Corrine Drive Study – Answers to Community’s Questions

Last Updated: May 14, 2019

Approximately 200 questions were submitted at the Corrine Drive Community Meeting on May 1. Time allowed for only a couple dozen questions to be answered. This document provides answers to the questions received.

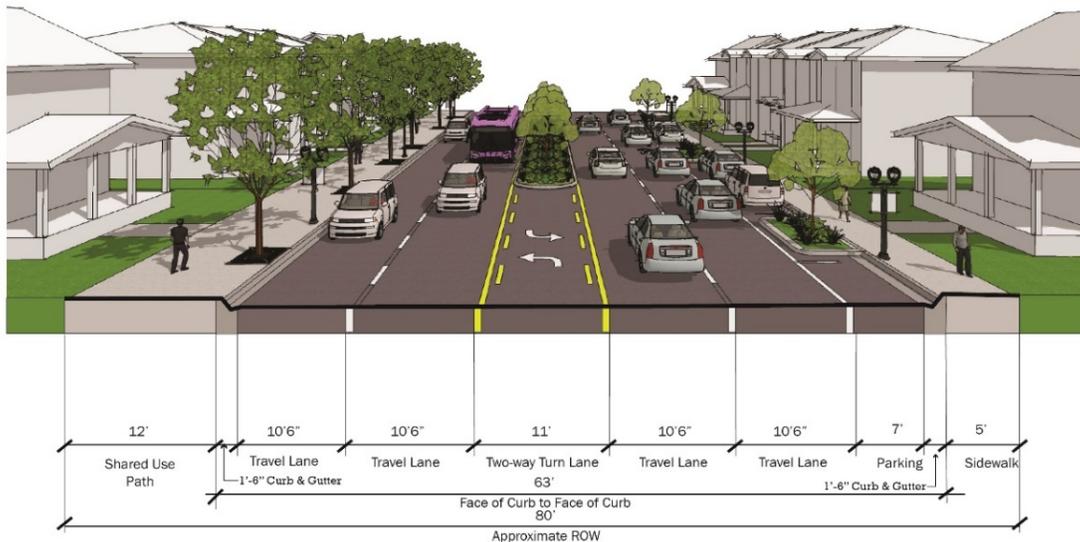
- *There is 8 feet between the Beeman Park houses and end of parking spaces. Will the 10 foot path be literally touching our homes?*
- *You keep saying “public right of way” but isn’t some of this path going to pave over some existing grass yard?*

- *How close to the houses will the path be to the houses around Oak and Palm. It seems incredibly invasive?*
- *How does this compare to the existing 80’ footprint?*

- *Do homeowners get compensated when you take their property for bike lanes?*
- *For residents like me, whose homes face Corrine Drive on the north side, how does the shared path impact our property? It looks like the path overlaps the property?*

Every feature included in the recommended design fits within the street’s existing 80’ of right of way. No feature will touch someone’s house. No one’s existing property is needed so no additional right-of-way will be purchased. There is 80’ of existing public space throughout the entire two mile street. The images below indicate the current and proposed sections between Palm/Bumby and the Christy/Janice Ave cross streets.

NOW

PROPOSED
